Proposed Temporary Warehouse (Timber and Other Associated Materials) for a Period of 3 Years and Associated Filling of Land in “Agriculture” Zone, Lot 129 S.A (Part) in D.D. 86 and Various Lots in D.D. 90 and Adjoining Government Land, Lin Ma Hang Road, Sha Ling (Compliance with Approval Condition (d) for Planning Application No. A/NE-MKT/35)

**Section 16 Planning Application for Proposed Temporary Rural Workshop
(Timber Yard and Sawmill) for a Period of 3 Years at Various Lots in D.D. 86 and
D.D. 90 and Adjoining Government Land, Lin Ma Hang Road, Sha Ling**

1. RESPONSES TO DEPARTMENTAL COMMENTS

Drainage Impact Assessment

Figure 7

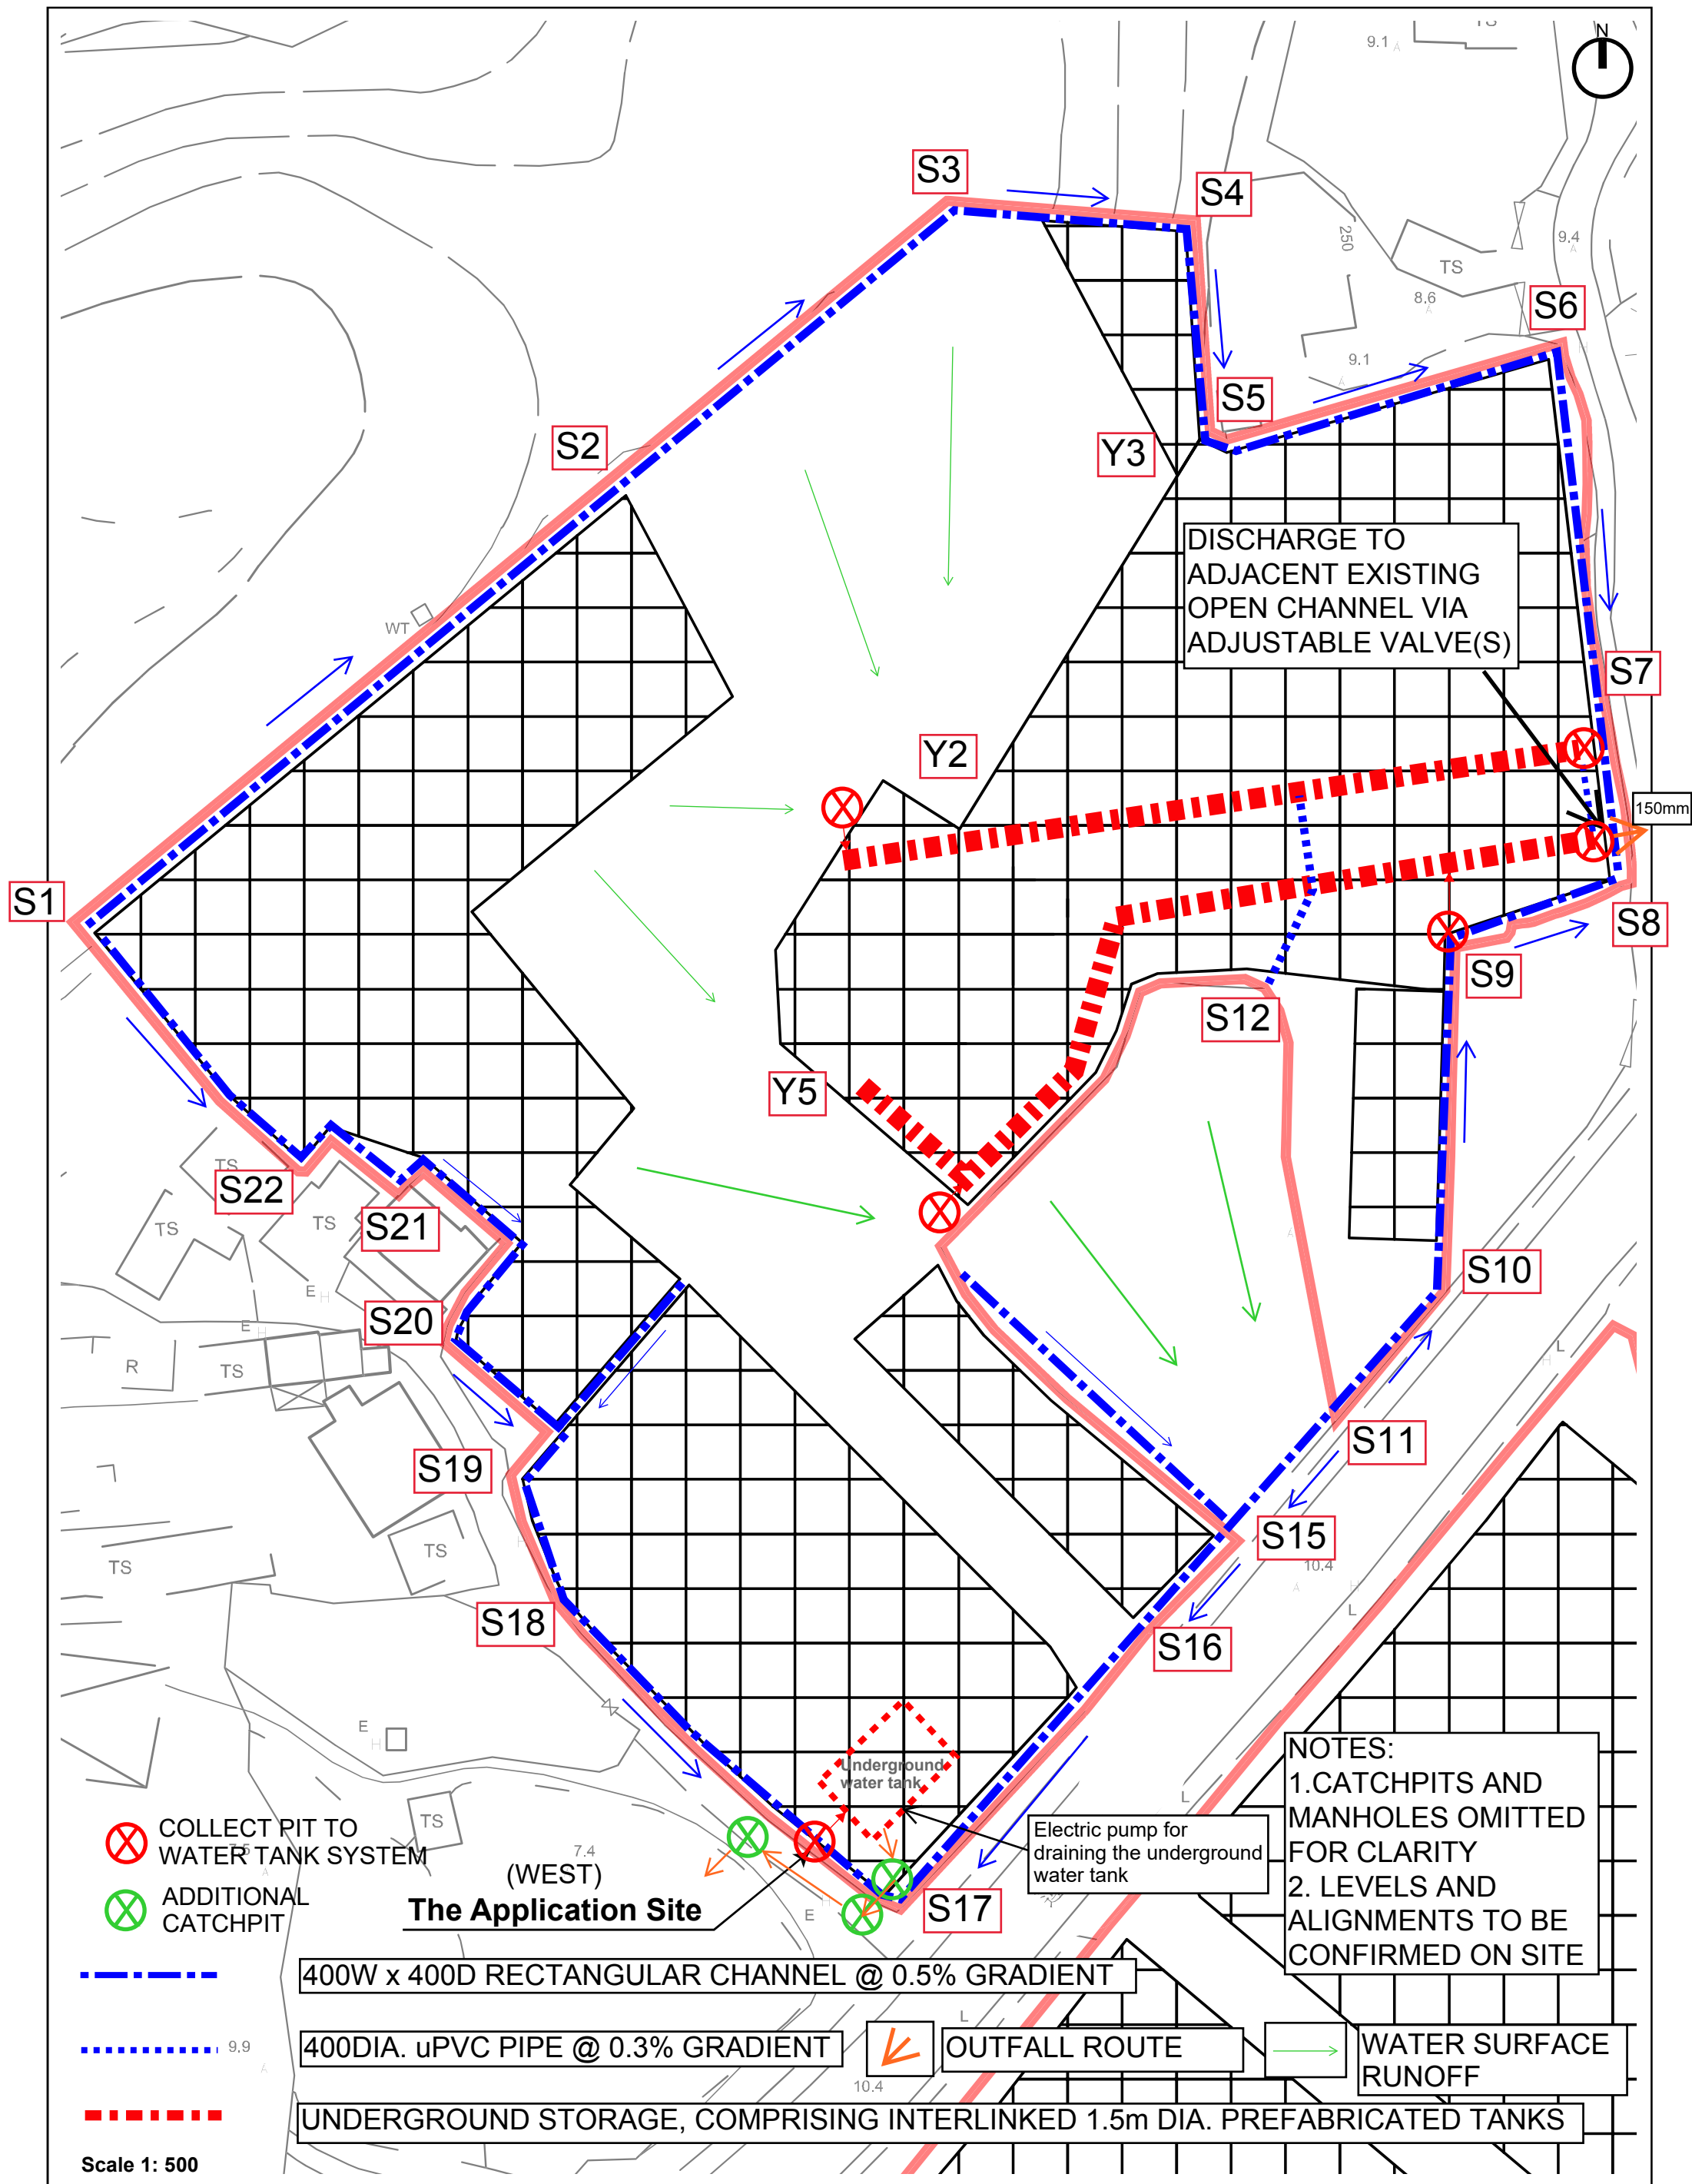
Item	Departmental Comments	The Applicant's Responses
DSD(1)	The location of underground water tanks at western side is different from the recommendation in approved Drainage Impact Assessment (DIA), please substantiate that the volume and effectiveness are equivalent to the original design.	According to the Applicant, the as-built underground water tanks currently provide a total storage capacity of 414 m³, which exceeds the recommendation set out in the approved DIA. This demonstrates an effectiveness that is equivalent to, or even superior to, the original design intent. Site CDE 區 (Western Site) 地下儲水缸 D 區 Ø1500 142m 251m² 進水位 Ø300 Y2 Y5 S7 S8 出水位 Ø0-100 S7 S8 Ø2400 x 12 x 3 163 m² 進水位 Ø300 自然泥入 S17 出水位 Ø50 水渠抽出 S17
DSD(2)	According to the DIA, storage water tanks are required at eastern side (Site A&B) while missing in as-built drawing, please clarify whether it was constructed and in operation.	The location of the underground storage water tanks has been indicated on the updated as-built drawing attached. The Applicant confirms it is constructed and in operation.

Item	Departmental Comments	The Applicant's Responses
DSD(3)	According to the DIA, upgrading works to the as-construction details for the eastern portion is required. Please clarify whether the upgrading works has been completed. 5.2.5 The construction works in the eastern portion of the Site, including the Site drainage facilities, have been completed (see photographs in Appendix C). The as-constructed details for the Eastern Portion have been checked against the latest design standards, as set out in Appendix I. The peripheral channels are generally adequate for the expected runoff, with the exception of a section along the (south-) western boundary of the Site (from Catchpits J to F2). It is proposed to upgrade this section, by either adding an additional uPVC pipe or by widening the as-constructed channel, with the final arrangement to be determined on-Site, to suit Site conditions. Both options have been assessed in Appendix I and are indicated on Figure 6.	According to the Applicant, an additional uPVC pipe has been constructed from Catchpits J to F2. Such detail has been indicated on the updated as-built drawing attached.
